BLRD-50-439/81-23

BELLEFONTE NUCLEAR PLANT UNIT 2 - LACK OF REBAR AT MAIN STEAM FLUED HEAD -
BLRD-50-439/81-23 - FIRST INTERIM REPORT

ENCLOSURE
BELLEFONTE NUCLEAR PLANT UNIT 2
LACK OF REBAR AT MAIN STEAM FLUED HEAD
BLRD-50-439/81-23
10 CFR 50.55(e)
FIRST INTERIM REPORT

REF: DWG 1AW0803-X2-3R1
VIEW IS SHOWN OPP HAND FOR
UNIT 2

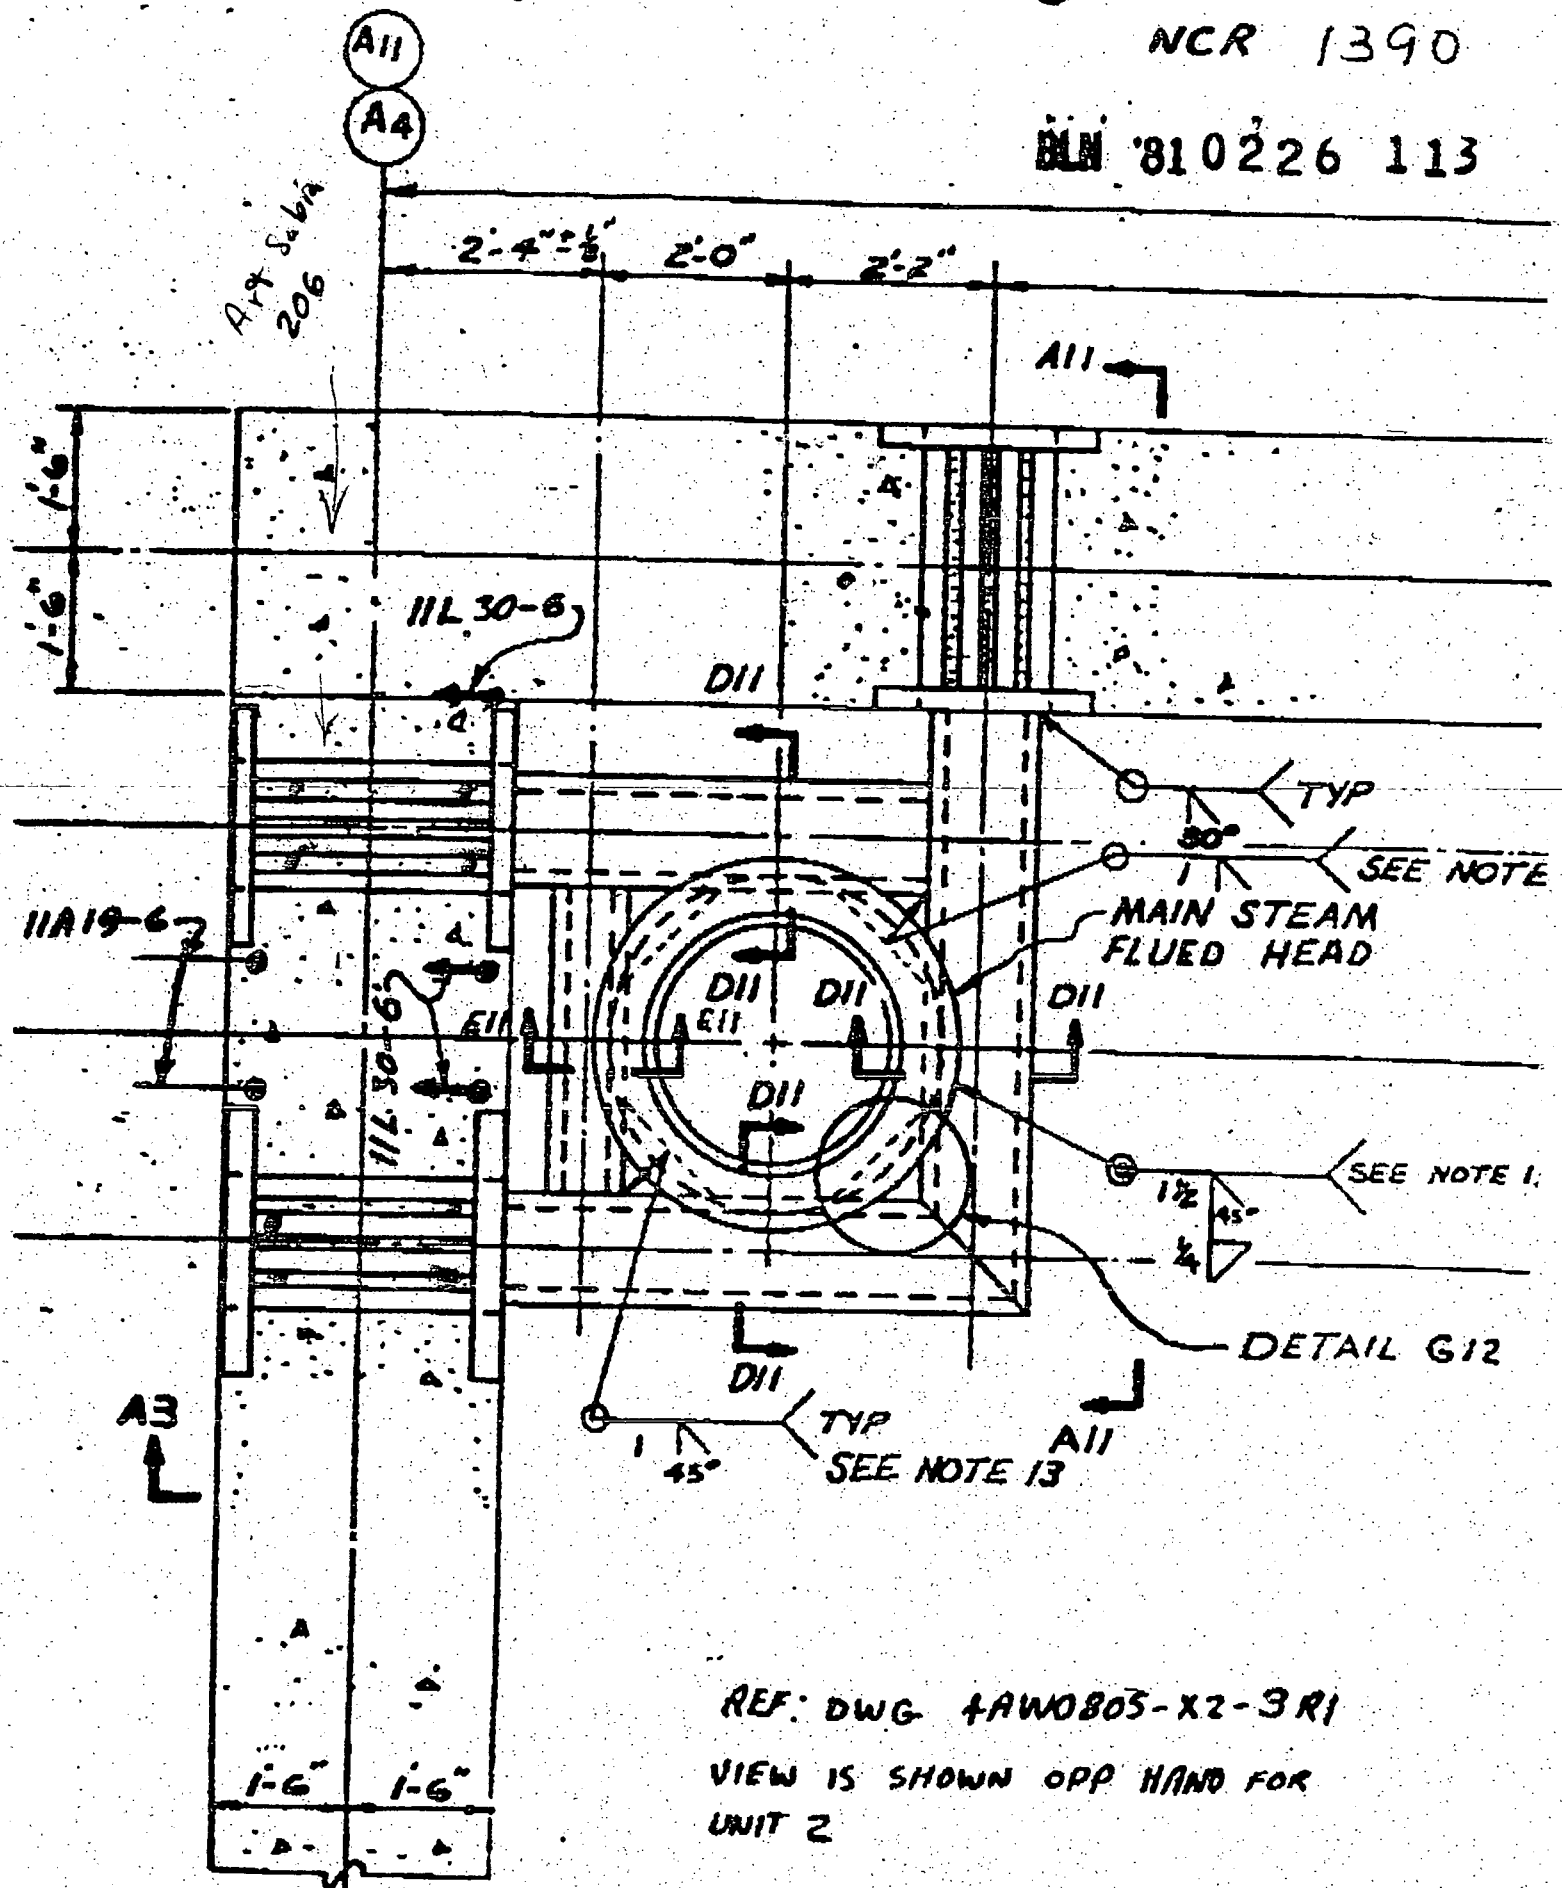
The discrepancy was discovered while chipping concrete, in accordance with the disposition of NCR 1308, to determine the locations of steel reinforcing bars (11A19-6 and 11L30-6) at the main steam flued head supports (see attached drawings). Chipping revealed that these bars are not present between said supports. Additionally, it was discovered that additional reinforcing bars which should lace between the anchor plate support bars were cut off below the supports. The extent and cause of the deficiency is unknown at this time.

Chipping will continue until exact location and configuration of the reinforcing bars are determined.

The remaining anchor assemblies in unit 2 will be chipped out and checked for the same type of rebar problems. In addition, two anchor assemblies will be checked in unit 1. (1) One located 6'-6" north of A4 column line wall in R column line wall and (2) One located in wall 3'-6" east of R column line wall and 8' north of column line A3.

When the efforts to determine the extent and cause of the deficiency are complete, appropriate corrective actions will be initiated.
